Report of the Strategic Director of Regeneration and Culture to the meeting of Bradford South Area Committee to be held on 25 June 2015.

SOUTHFIELD LANE, BRADFORD OBJECTIONS TO A PROPOSED RAISED ZEBRA CROSSING AND ROAD HUMPS

This report considers objections to recently advertised proposals for a raised zebra crossing and road humps on Southfield Lane, Bradford.

APPENDIX 1

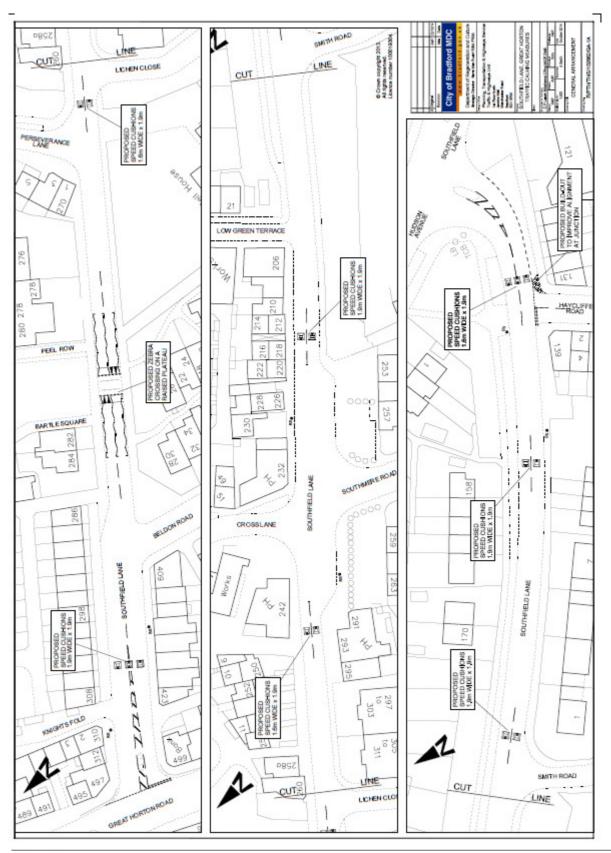
Ref	Grounds for objection	Officer comments
1	Removal of on-street parking on Southfield Lane and the potential resulting parking issues at the end of Peel Row and Bartle Square.	The proposed zig-zag markings are the minimum required to ensure safe intervisibility at the crossing. The net impact on parking is minimal and there would be safe alternative parking opportunities within a short distance on Southfield Lane either side of the proposed facility. Due to the limited carriageway widths, parking on either Bartle Square or Peel Row would constitute and obstruction and would be enforceable as such. The provision the zig-zags would further discourage any parking across the ends of these roads.
2	The zebra crossing will lead to more pedestrians using Peel Row – concerns about property security	Peel Row is a legitimate pedestrian thoroughfare. Notwithstanding this, the

3	Littering Bin collection arrangements	proposed location of the zebra crossing is not expected to have a significant impact on overall pedestrian routes. It is not expected that the proposed measures would have any impact of littering Alterations have been made to reduce the number of zigzags on the zebra crossing which should result in minimal disruption to bin collections.
5	Concerns for safety of home, business and pedestrians as drivers will avoid the humps by mounting the pavement.	This is not expected to be an issue at the particular location that has been highlighted as there is an existing kerb that would make traversing a speed cushion no less attractive. Despite this, all traffic calming feature locations would be vetted prior to scheme implementation and any additional kerbing works or bollards installed as appropriate.
6	Noise	The proposed features are designed and spaced to minimise impact noise by encouraging overall slower speeds. Such features are commonplace within the district and noise has not been particularly highlighted as an issue.

7	Loss of control	The proposed features are designed and spaced to provide safe self-enforcing vehicle speeds. The installation of these measures would reduce overall vehicle speeds along with the probability of any loss of control incidents.

2.4 In view of the objectors' concerns about the potential impact of the scheme on bin collections and access, the proposal has been modified to reduce the length of zig-

zags. The revised proposal is shown on Drawing No R/PTH/TH/S/102662/GA-1B, attached as Appendix 2.

- 10.1 That the objections are overruled and the proposed raised zebra crossing and traffic calming measures on Southfield Lane be implemented subject to the modifications detailed on Drawing No. R/PTH/TH/S/102662/GA-1B attached as Appendix 2 to this report.
- 10.2 That the objectors are informed accordingly.
